AGENDA ITEM SUMMARY

SUBJECT: Draft Tree Ordinance

STAFF REPORT

TO: Hailey City Council
FROM: Beth Robrahn, Planning Director 
RE: Preliminary Plat and Floodplain Development Permit – Lots 15A and 15B, Birdwood Subdivision
HEARING: July 14, 2008

PROFILE
N.T.S.

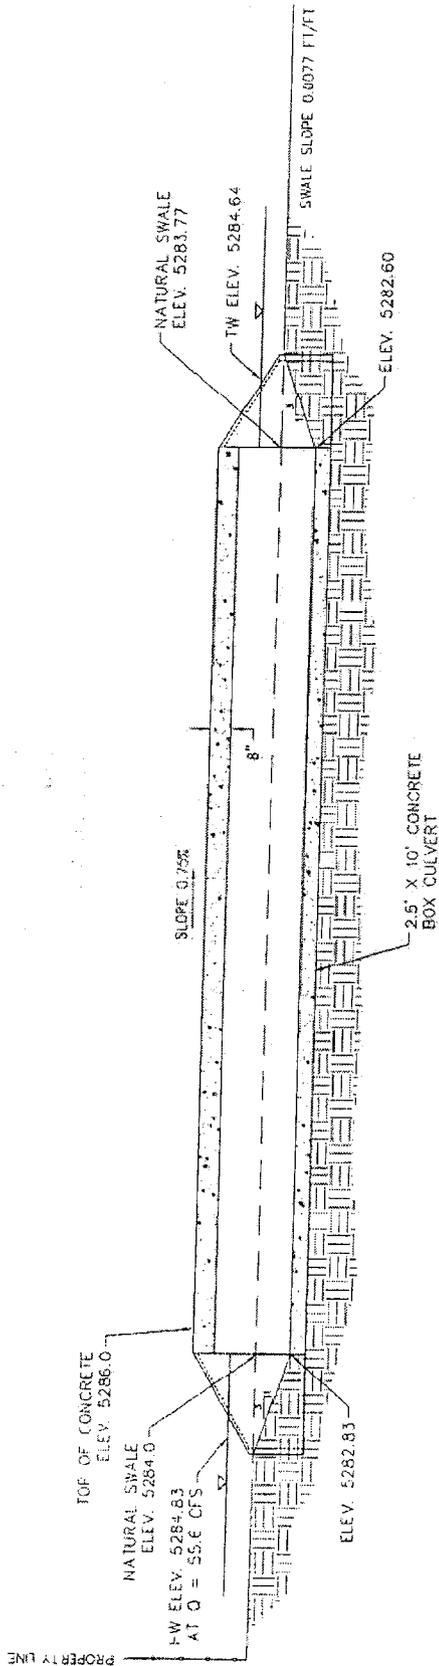
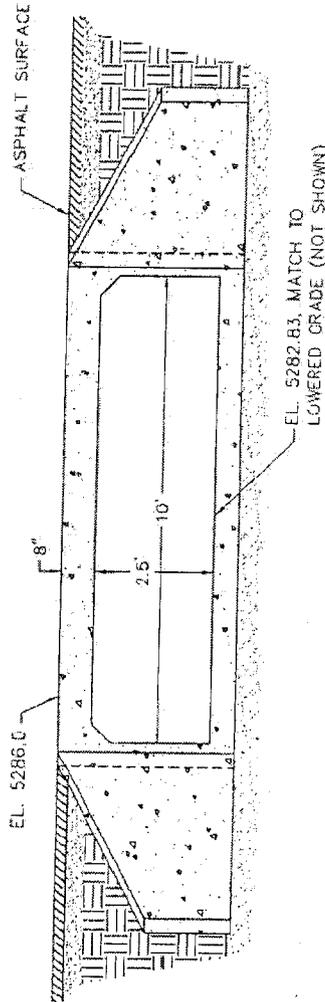
In his June 24, 2008 revised design description, Chuck Brockway wrote: "The model indicates that with one (1) 2.5'x10' box culvert with wingwalls, the headwater elevation at Q = 55.6 cfs will be 5284.83 feet, which is 0.04 feet less than the "natural" WSE."

Although this revised design results in a calculated headwater elevation 0.01 ft higher than that of the four pipe-arch design, both designs result in headwater elevations below that calculated for the native condition.

Brockway has recently revised the culvert design from four parallel pipe-arch culverts to one 2.5 ft x 10 ft box culvert with wing walls. The City has asked SPF to provide a similar review of this revised design. The design flow and other assumptions stated in prior analysis remain unchanged; only the culvert structure is revised.
